T10/07-409r0

To INCITS T10 Committee      From Michael Banther, HP      Subject SSC-3 Volume Model

Date  
18 September 2007

Figure 4 – Typical recording medium track layout

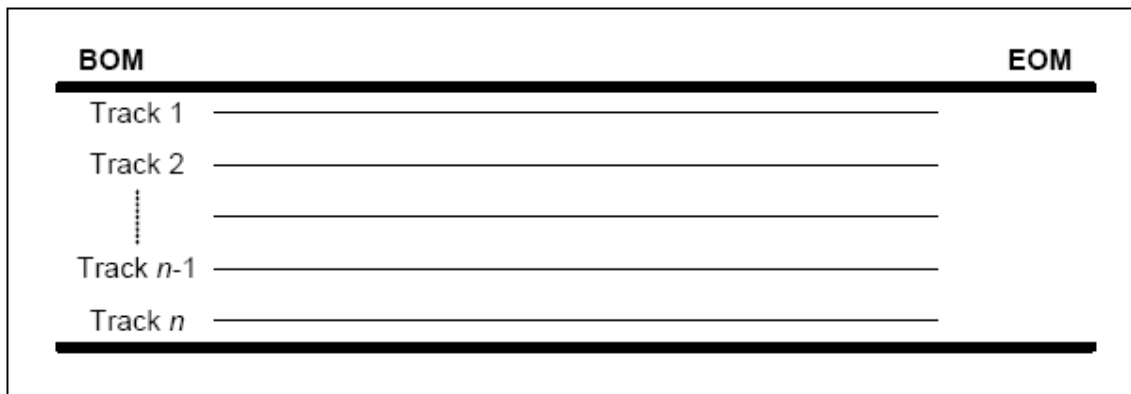
The position on the recording medium where one write component records a pattern of recorded signals ~~may be written by one write component~~ is called a track (see figure 4). A device may write or read from one or more tracks at a time, depending on the format.

**Figure 5 – Serpentine recording example**

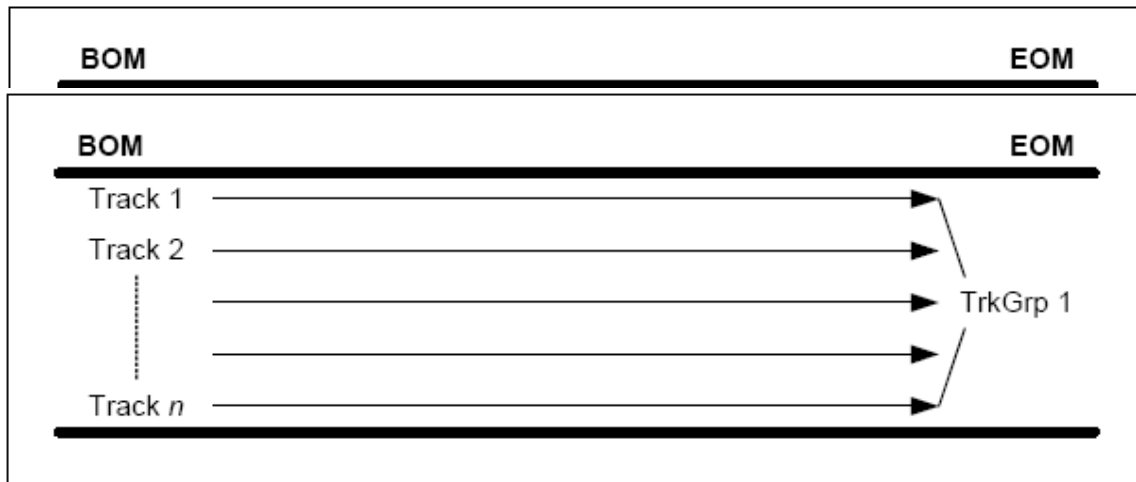
In serpentine recording, not all tracks are recorded at the same time. At the end-of-medium or beginning-of-medium, the device reverses direction and begins recording the next track group. The process of reversing direction and recording the next track group ~~may be repeated~~ repeats until all track groups are recorded. For serpentine devices that record only one track at a time, each physical track represents one track group (see figure 5).

**Figure 7 – Helical scan recording example**

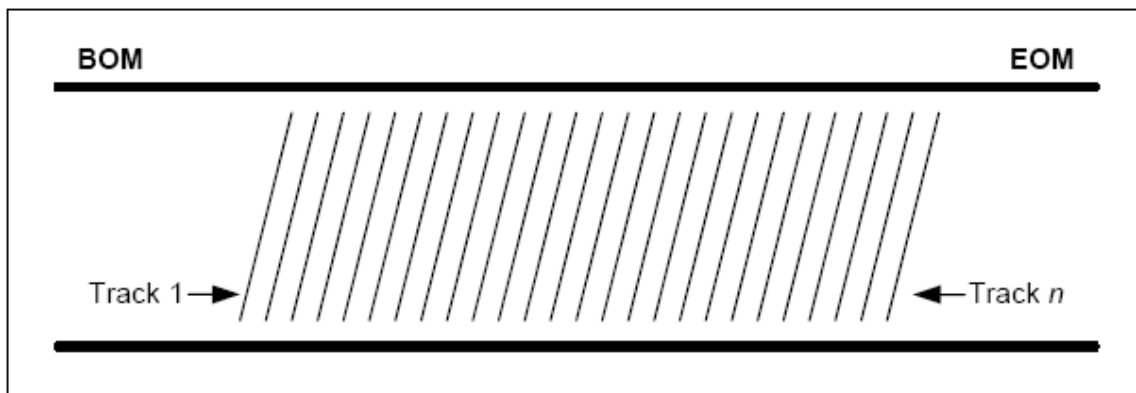
The serpentine and parallel recording formats shown in the previous examples define tracks as longitudinal patterns of recorded information. One other storage format used by some devices records tracks diagonally across the recording medium. Recording of one or more tracks ~~may be recorded~~ occurs at the same time. This recording technique is known as helical scan (see figure 7).

Figure Y – Typical cleaning medium layout

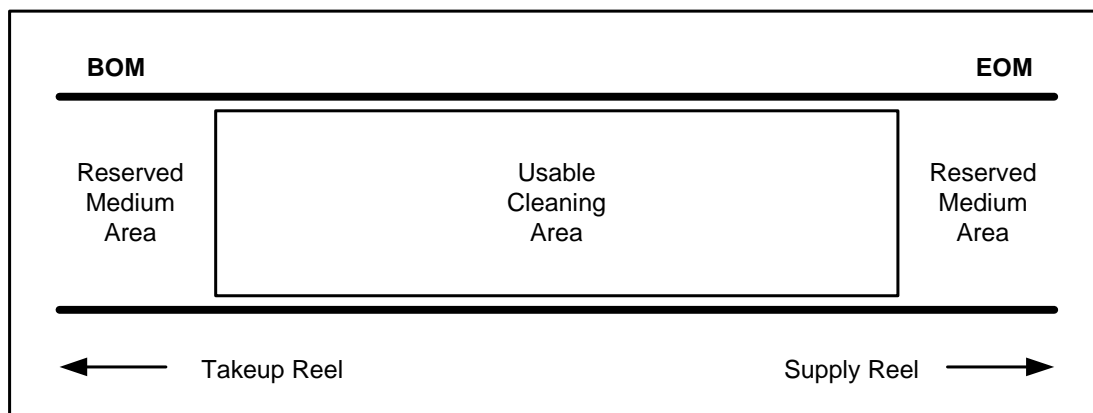
As shown in figure Y, a portion of the physical length of a cleaning medium is not usable for abrading the read/write mechanism. For most cleaning volumes, a length of the cleaning medium is reserved between the take-up reel and the beginning-of-medium, and between the end-of-medium position and the supply reel. This is done to provide a sufficient tape wrap onto the reel hub and to ensure that interactions between the abrasive substrate and the read/write mechanism start in an undamaged section of the medium.
